01 Floor plans

Level 04 Floor Plan

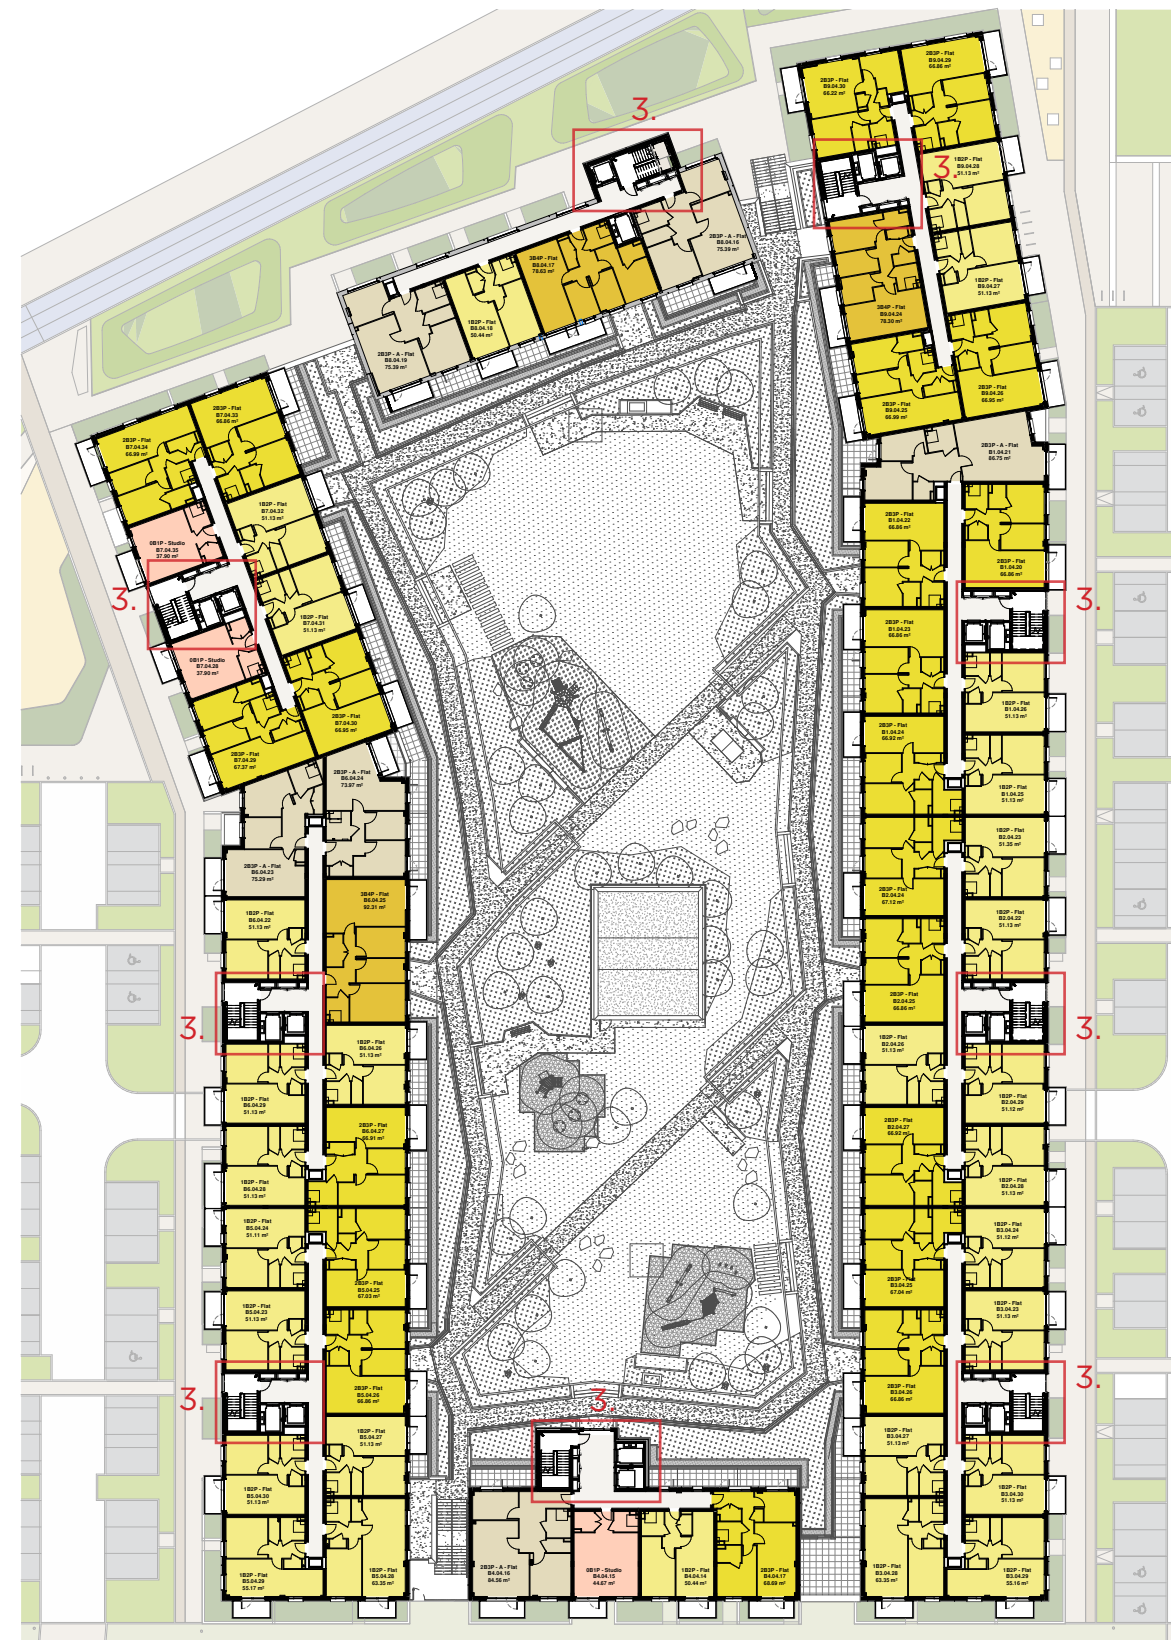
1. Omission of podium entrance canopies; security risk to adjacent apartments at first floor.
2. Addition of plant housing for car park smoke extract fans as per developed fire strategy
3. Updated core layout as per developed fire strategy; evacuation lifts added to Blocks 4 and 8
4. Reconfiguration of apartment layout. Overall mix remains as consented.

Level 05 Floor Plan

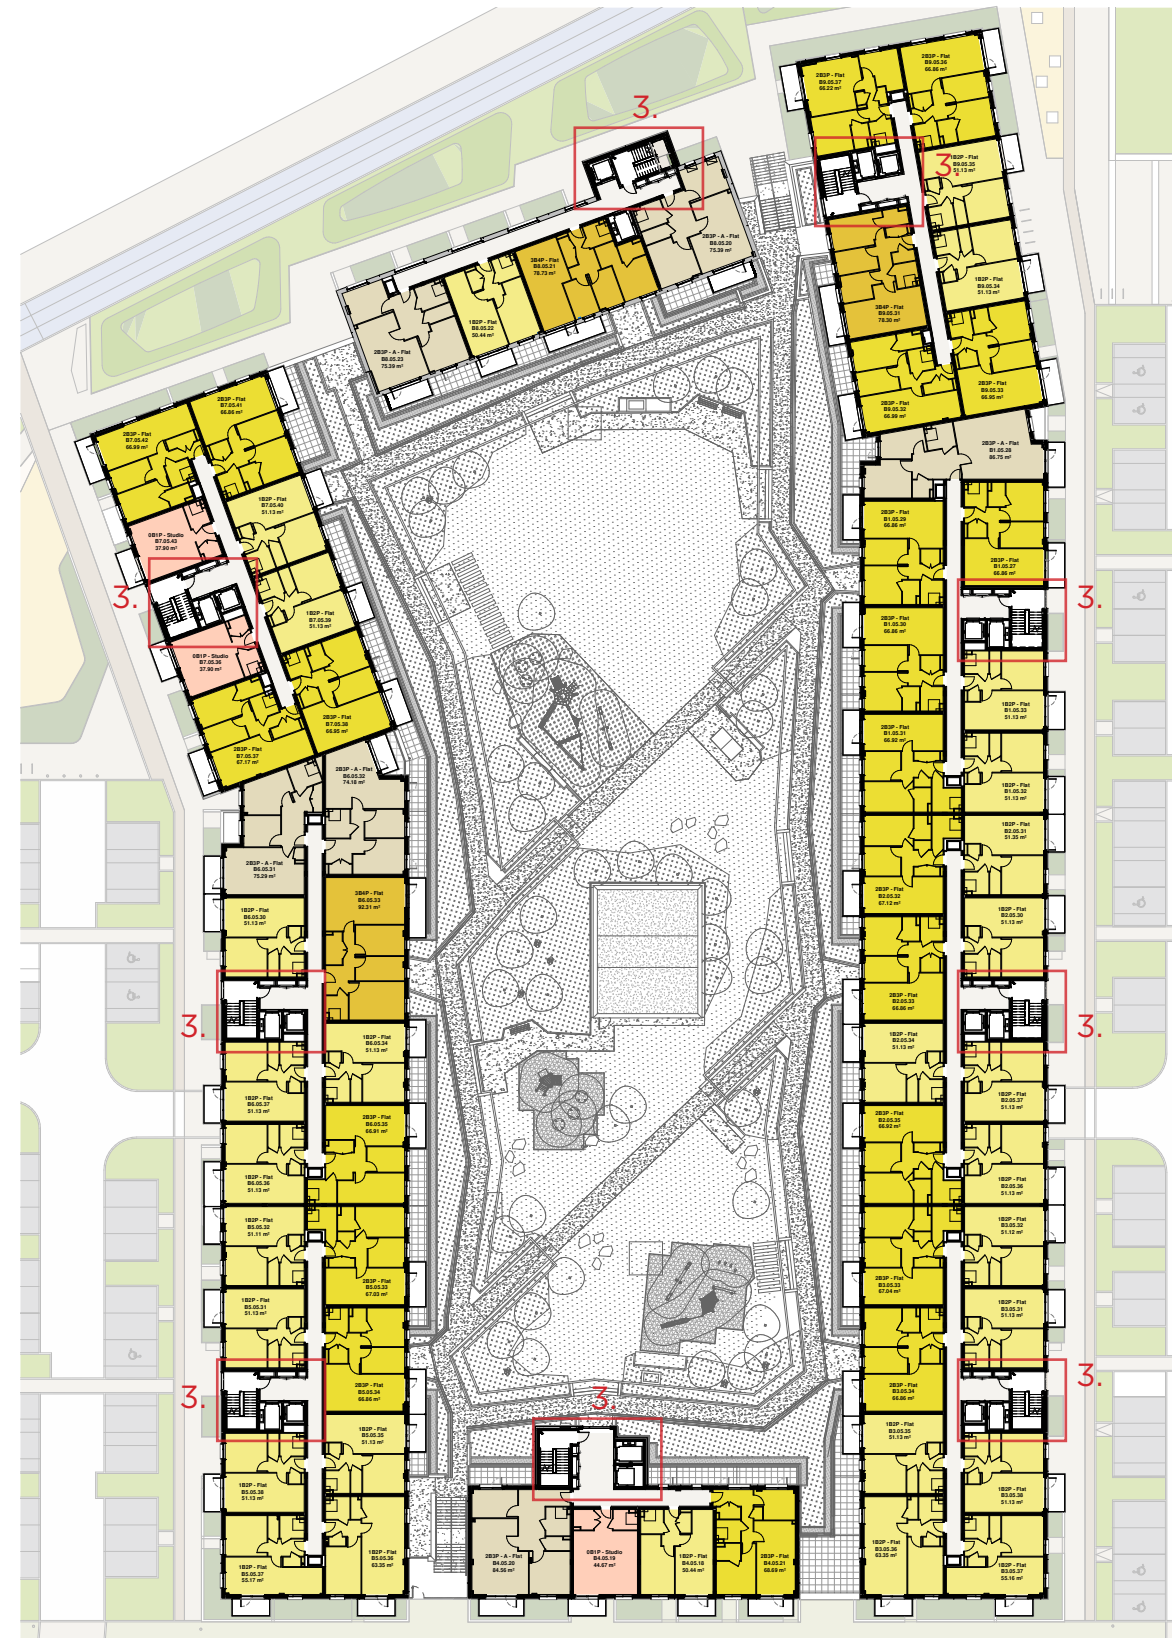
1. Omission of podium entrance canopies; security risk to adjacent apartments at first floor.
2. Addition of plant housing for car park smoke extract fans as per developed fire strategy
3. Updated core layout as per developed fire strategy; evacuation lifts added to Blocks 4 and 8
4. Reconfiguration of apartment layout. Overall mix remains as consented.
